# **Structural Glitch Modifications**

This document created by the Florida Department of Community Affairs -  
850-487-1824

**Sub Code: Building**

Total Mods for Structural: 115

Figure 1609C Ultimate Design Wind Speeds,  $V_{ult}$  for Risk Category I Buildings and other Structures

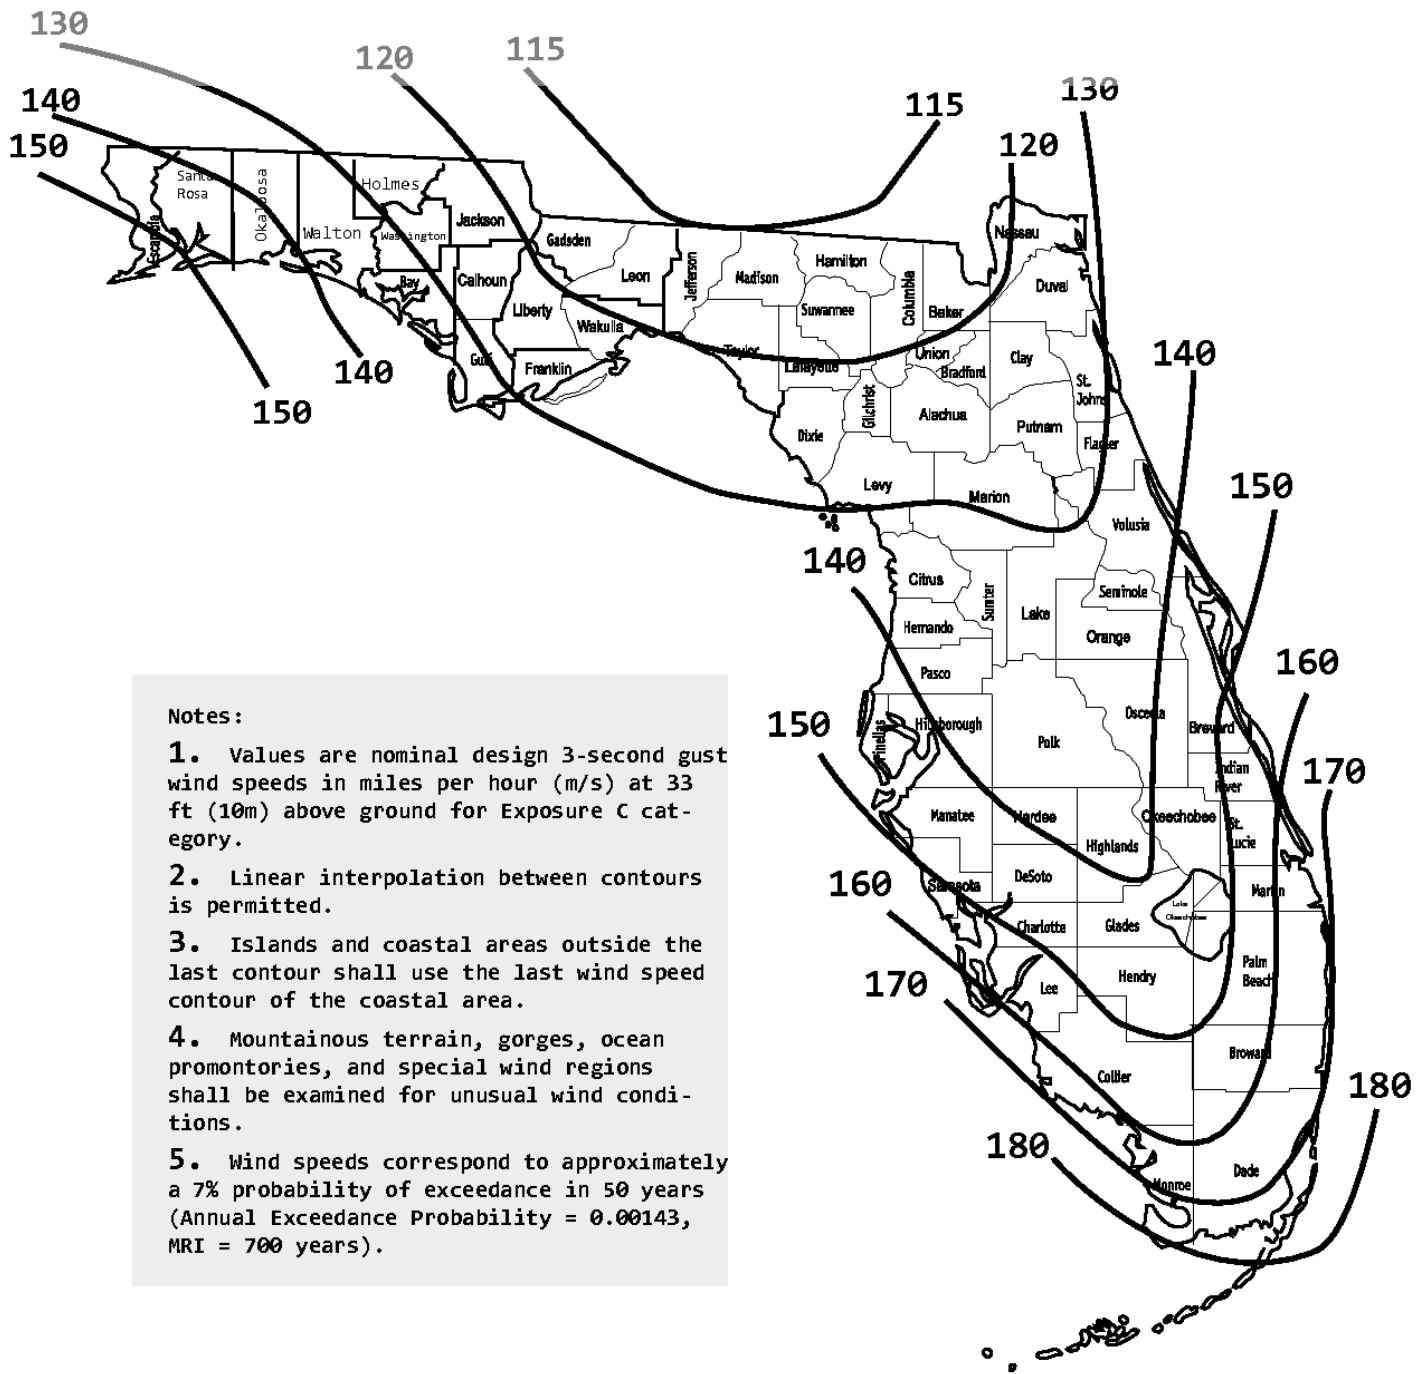
Editorial - To magnify the wind maps to provide greater clarity and resolution

**See Attached Figure 1609C**

Figure 1609A Ultimate Design Wind Speeds,  $V_{ult}$ , for Risk Category II Buildings and Other Structures

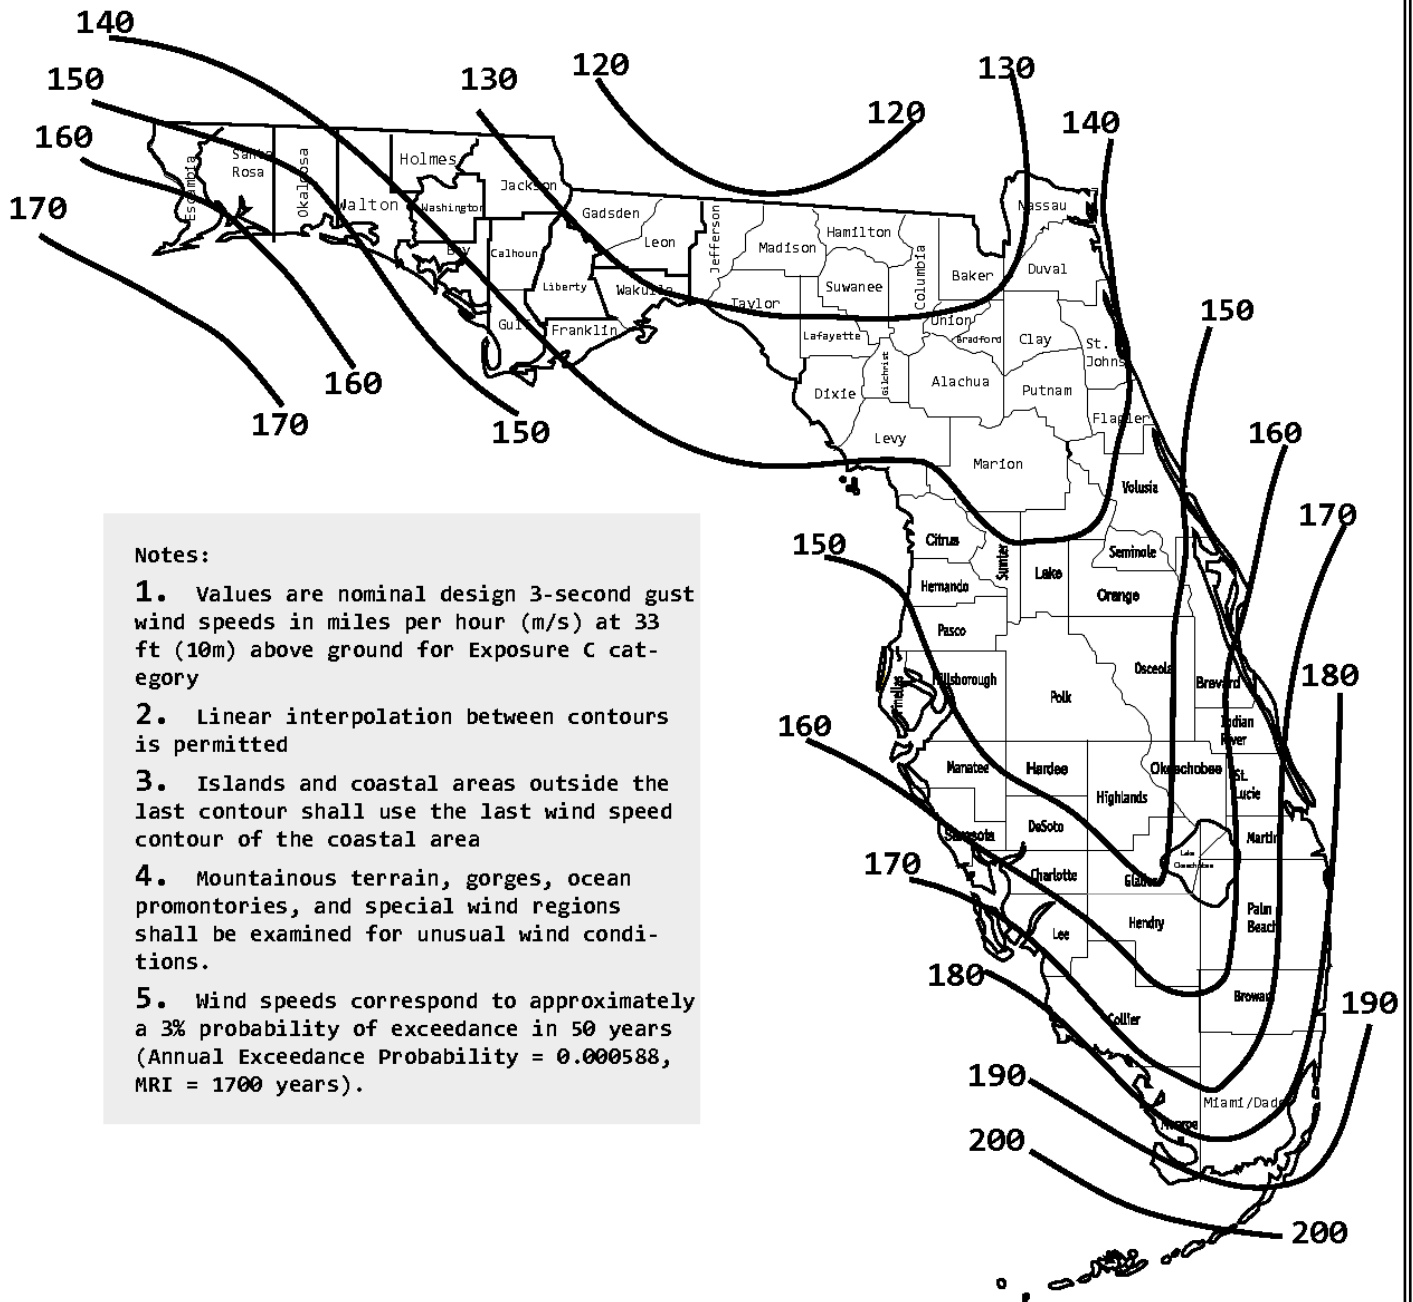
**See Attached Figure 1609A**

Figure 1609B Ultimate Design Wind Speeds,  $V_{ult}$ , for Risk Category III and IV Buildings and other Structures

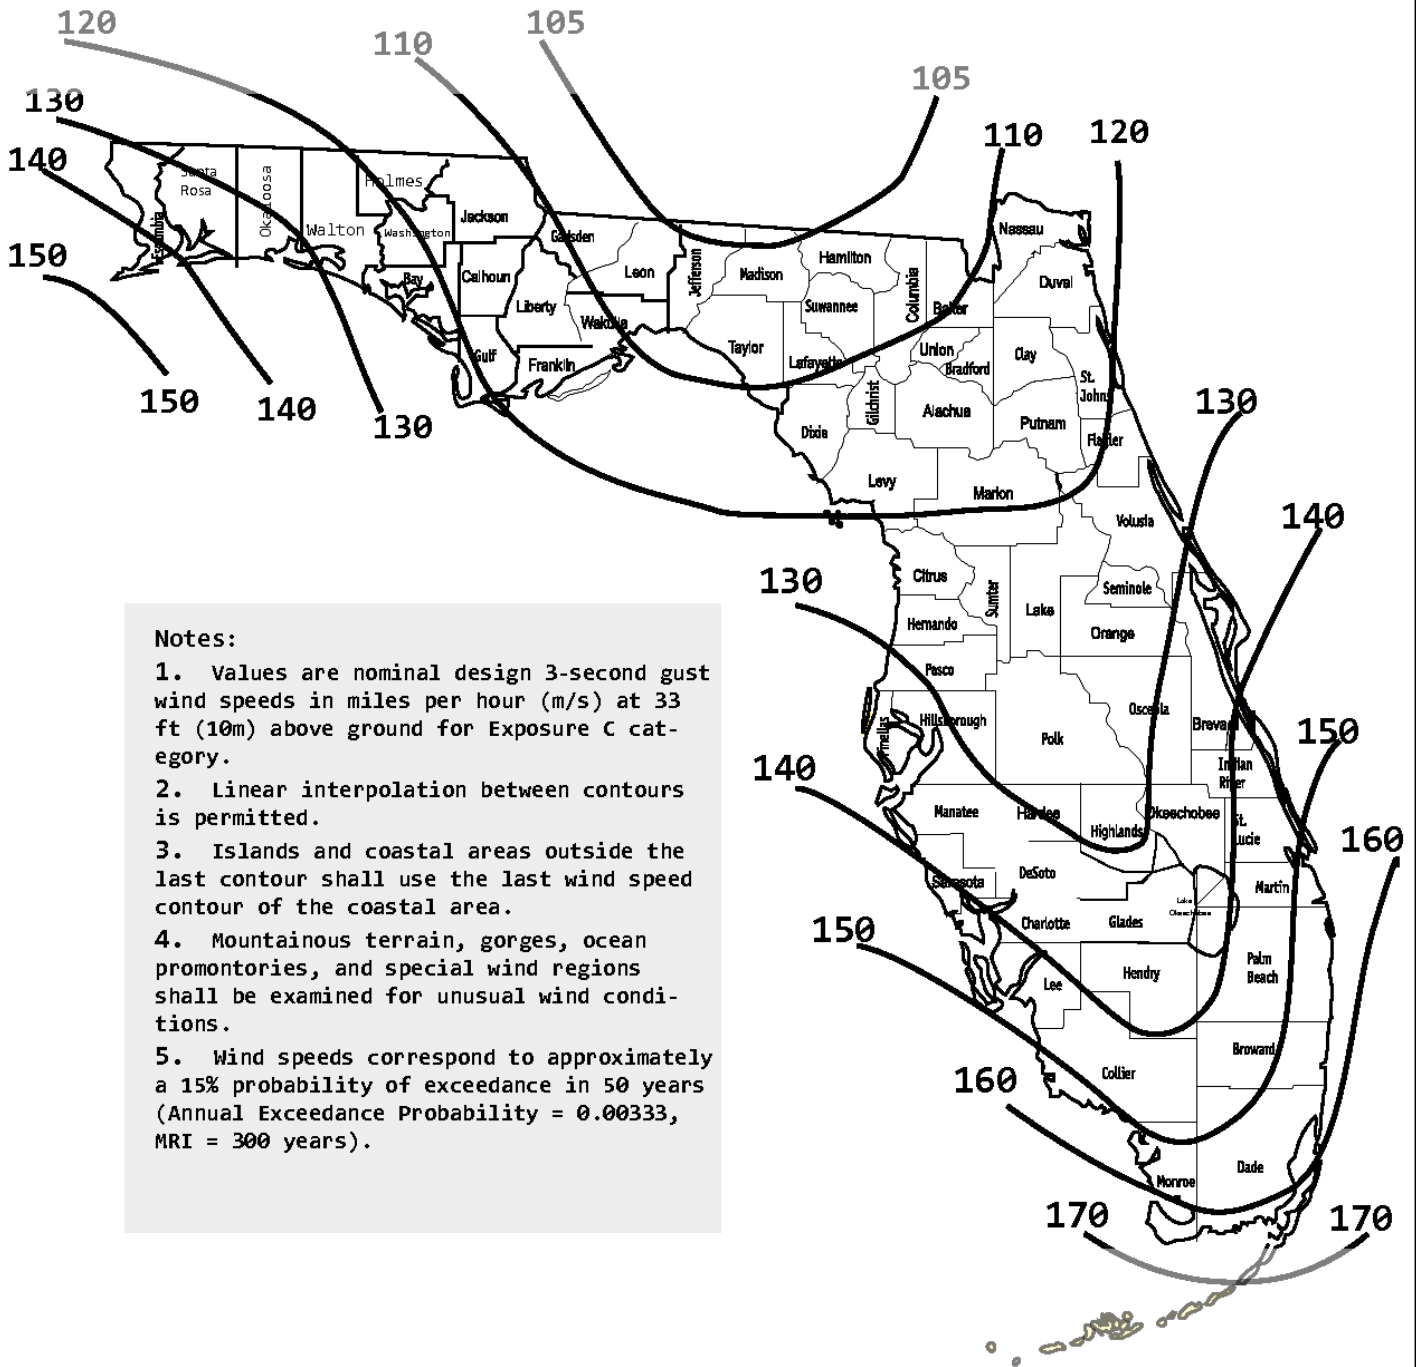
**See Attached Figure 1609B**

Figure R301.2(4) Ultimate Design Wind Speeds,  $V_{ult}$

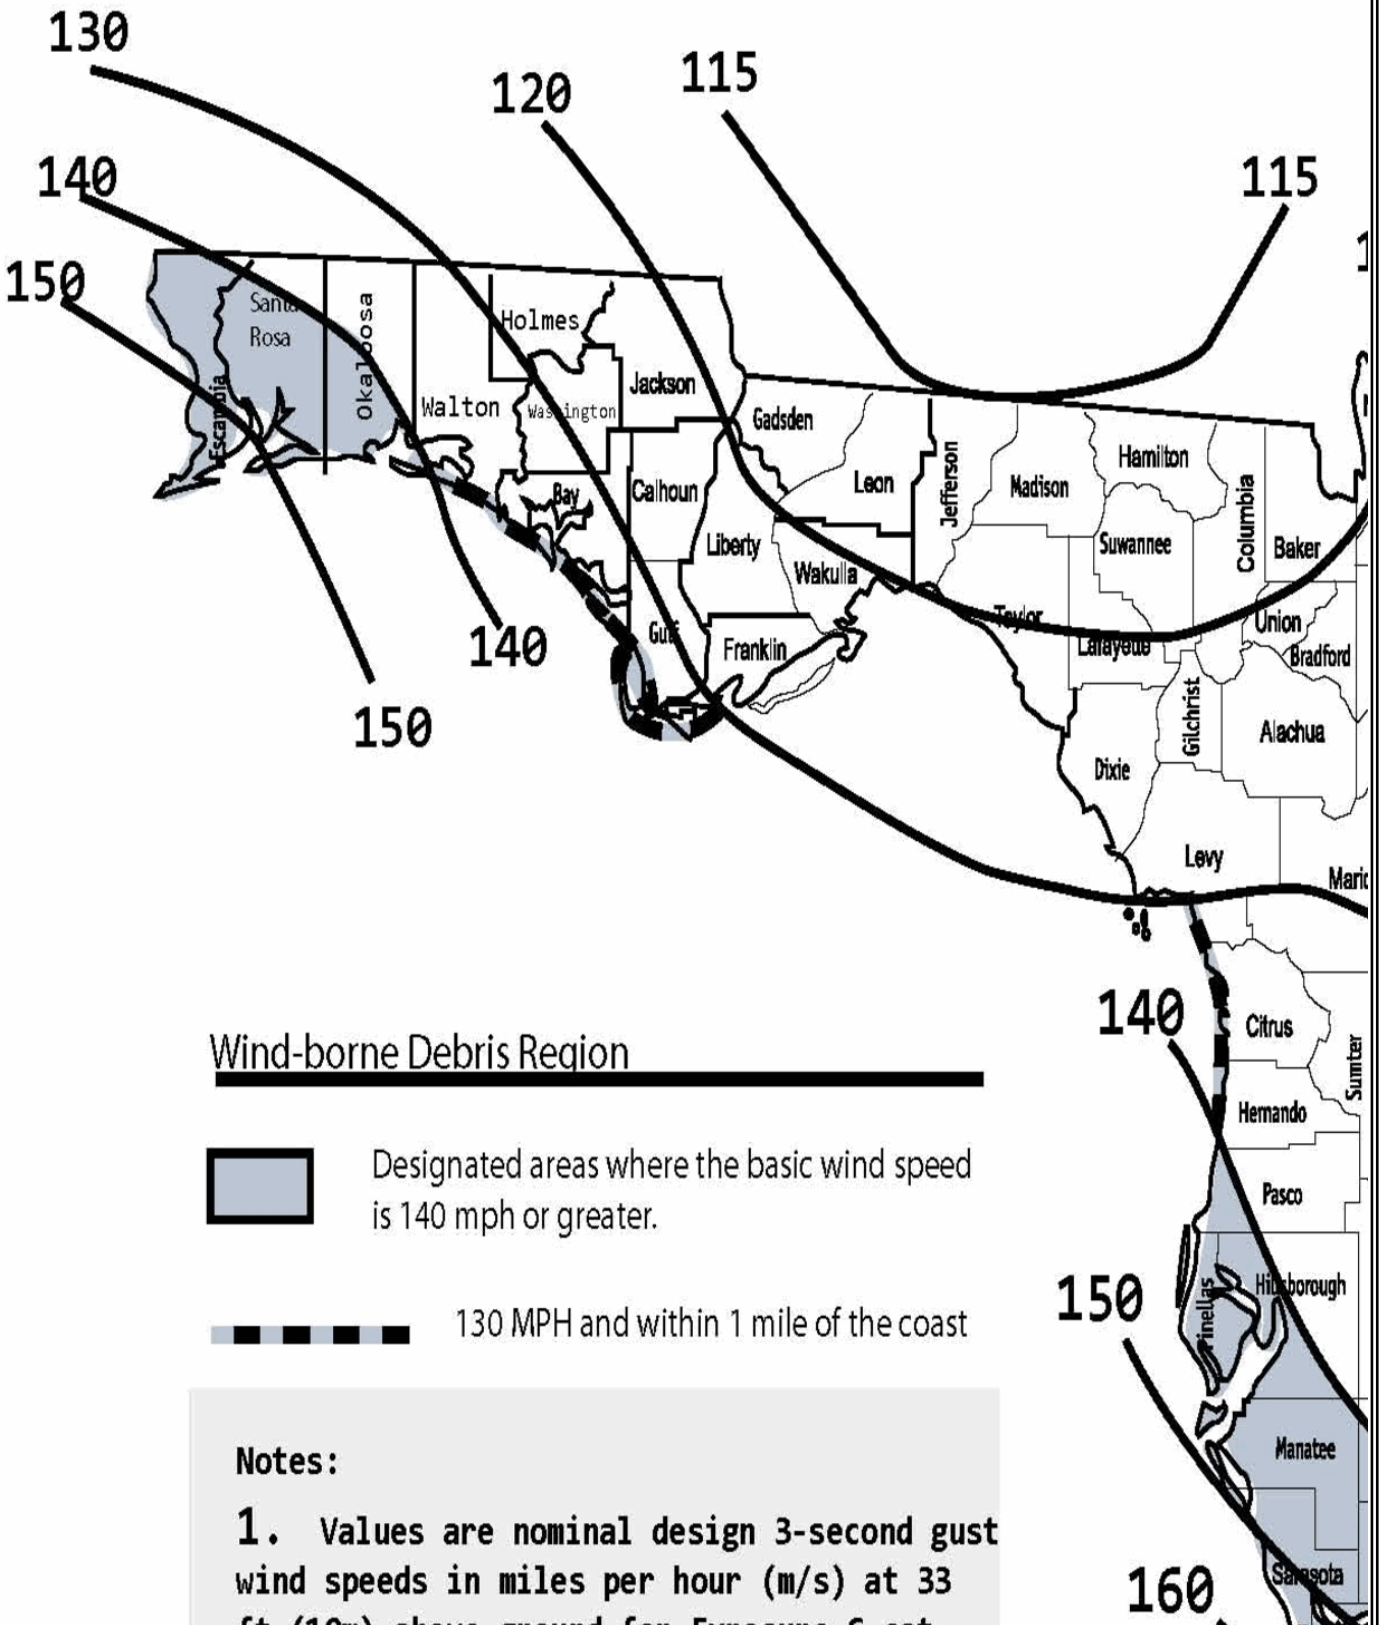
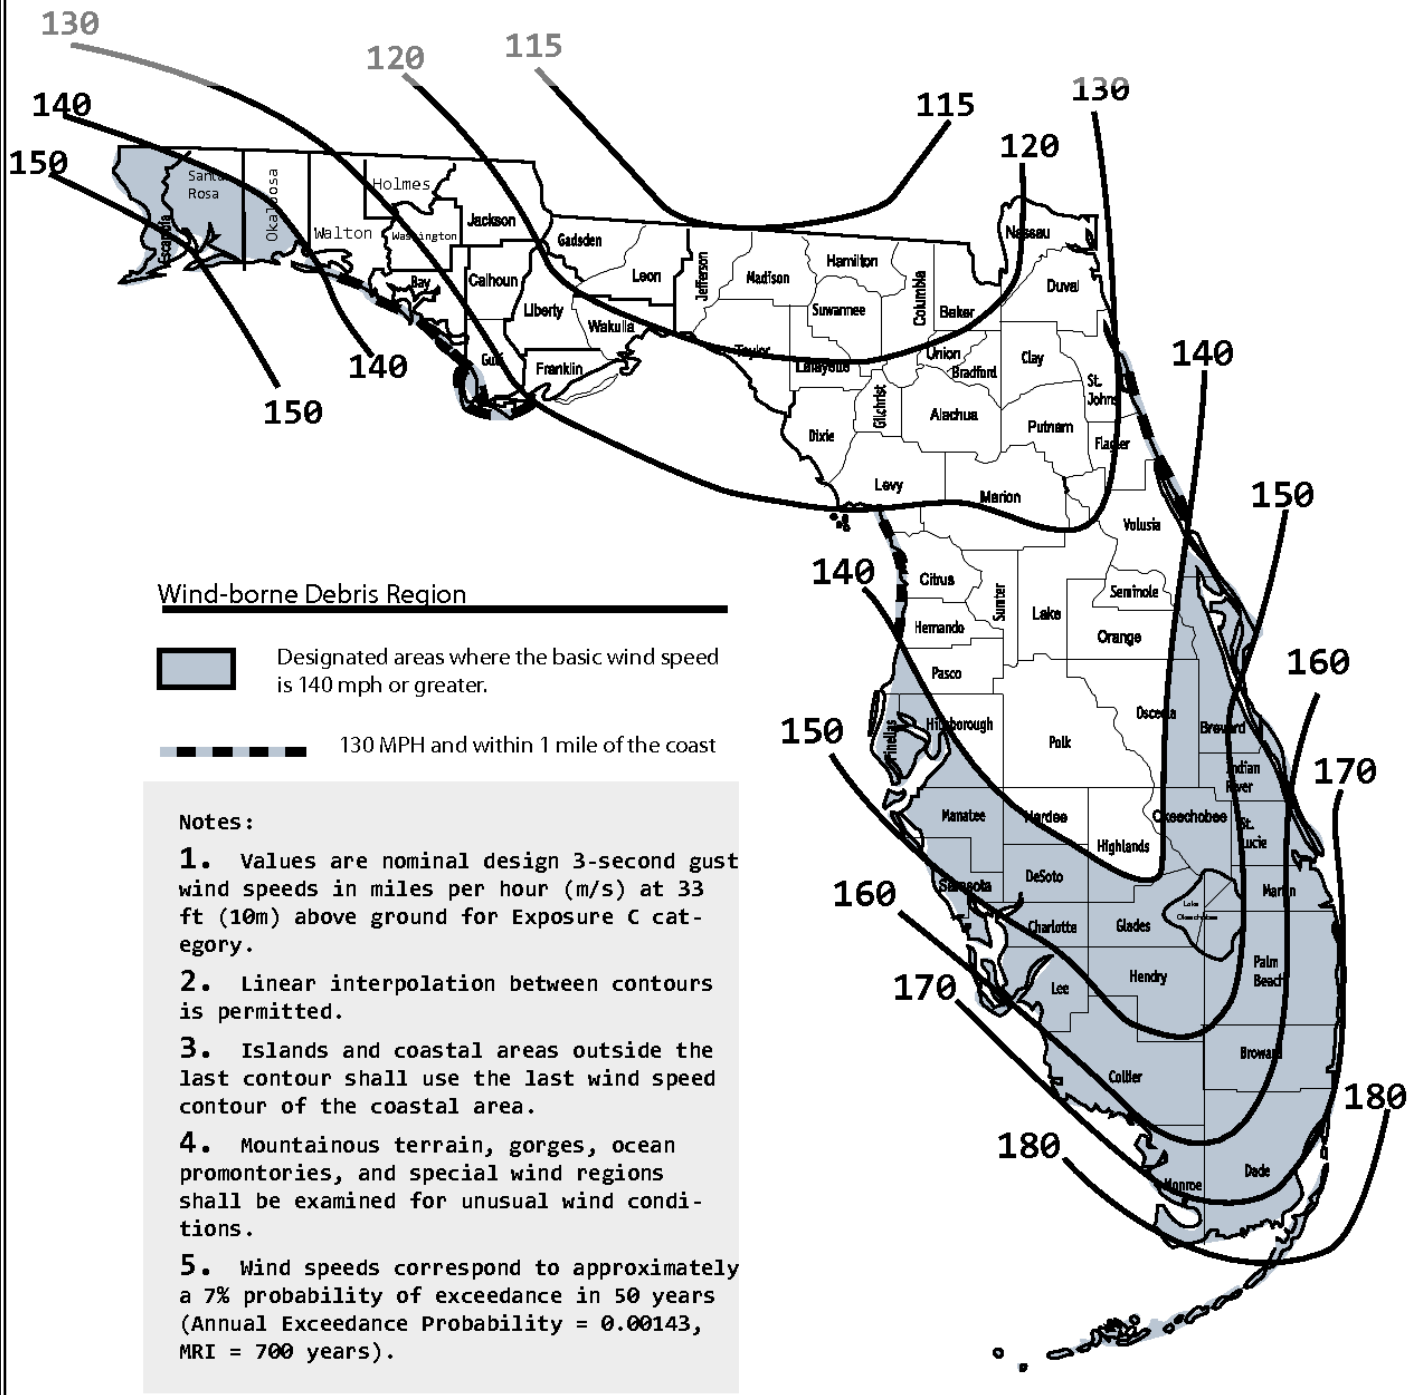
See Attached Figure R301.2(4)

FIGURE R613.5(3)  
TRUSSED ROOF TO TOP PLATE CONNECTION

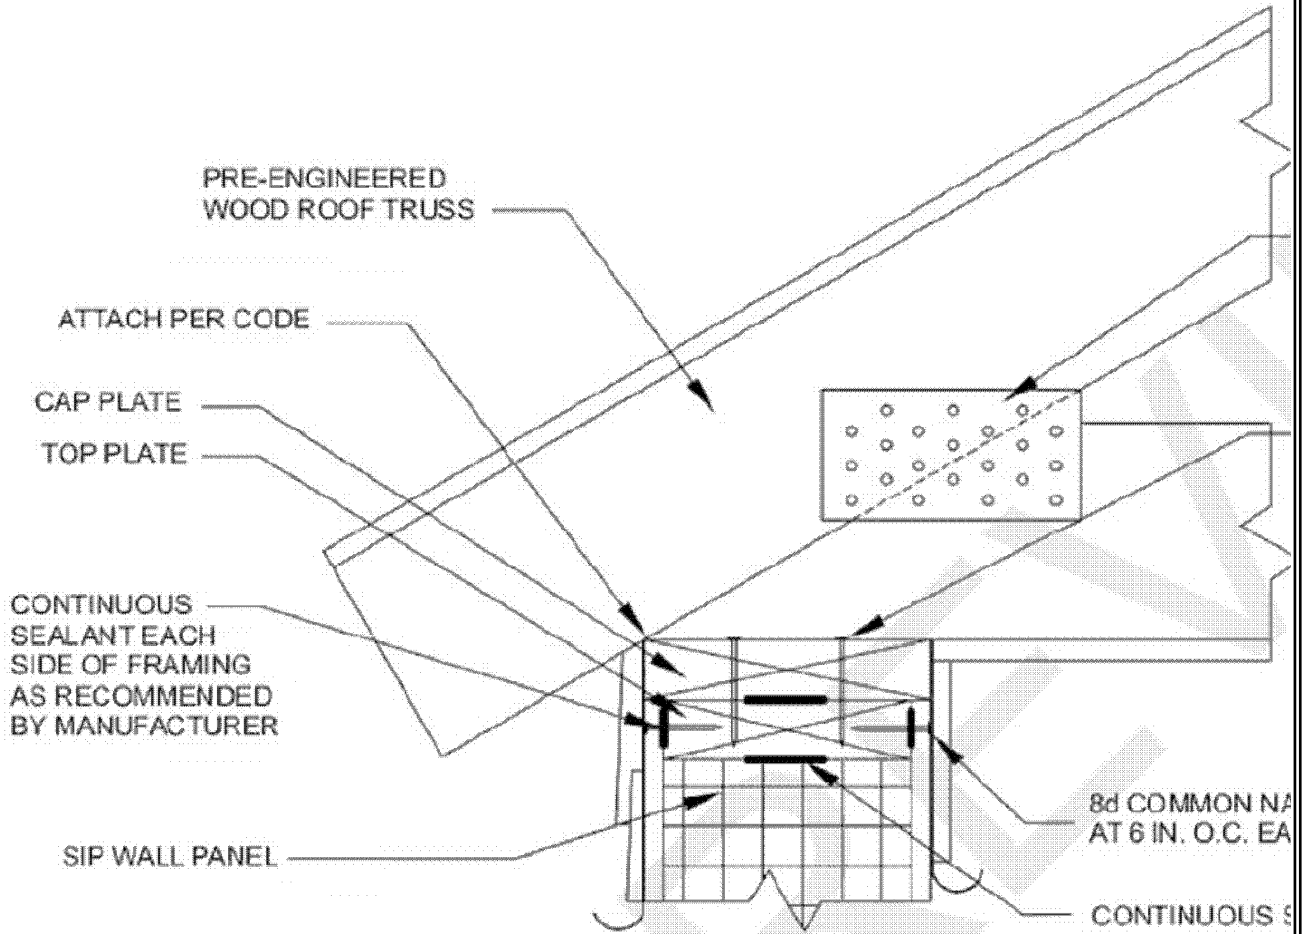
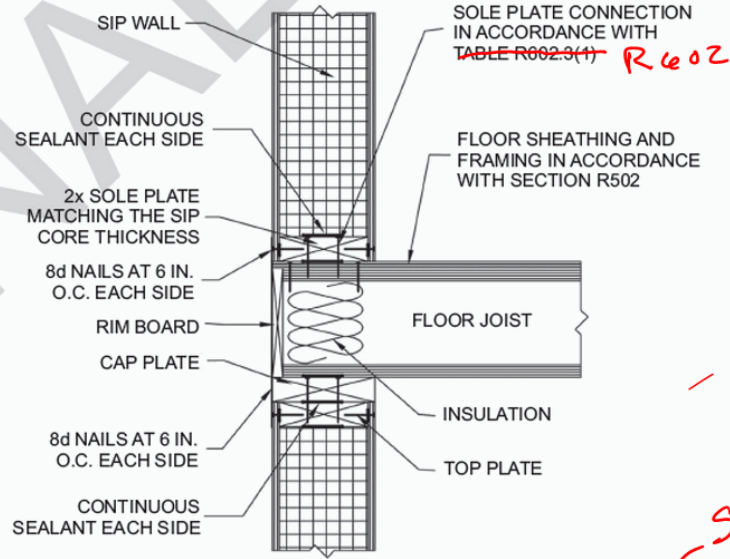
Note: Figures illustrate SIP-specific attachment requirements. Other connections shall be made in accordance with ~~Table R602.3(1) and (2)~~ as appropriate.
